SEWAGE DISPOSAL SYSTEM

MARYLAND STATE DEPARTMENT OF HEALTH

IS PERMITTED TO INSTALL _____ ALTER X

ROAD 13994 Burntwoods Road

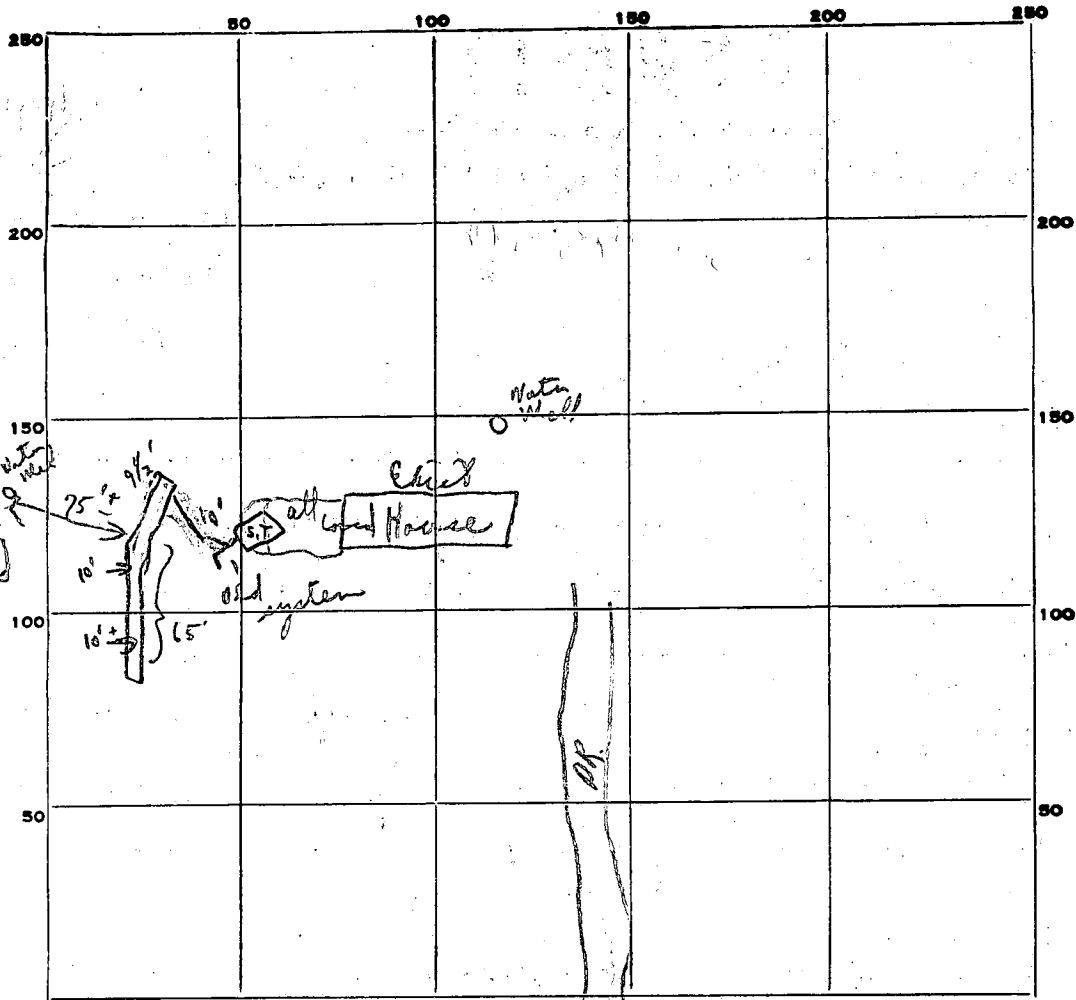
OTHER REPAIR-CALL FOR INSPECTION WHEN GROUND IS OPENED UP SO SANITARIAN CAN

RECOMMEND REPAIR.

60' Turned 6' stone - Keep 75' away
From neighbors well, 10' From prop line and ex system 10/24
10/26/77

REMARKS 10/31/77 OK for gravel; saw 10' cast iron + cement
c/Iron to old system + new pipes. ok to cover to trench
OK gravel + pipes on to 2-2 1/2' from surface. c.B.A.
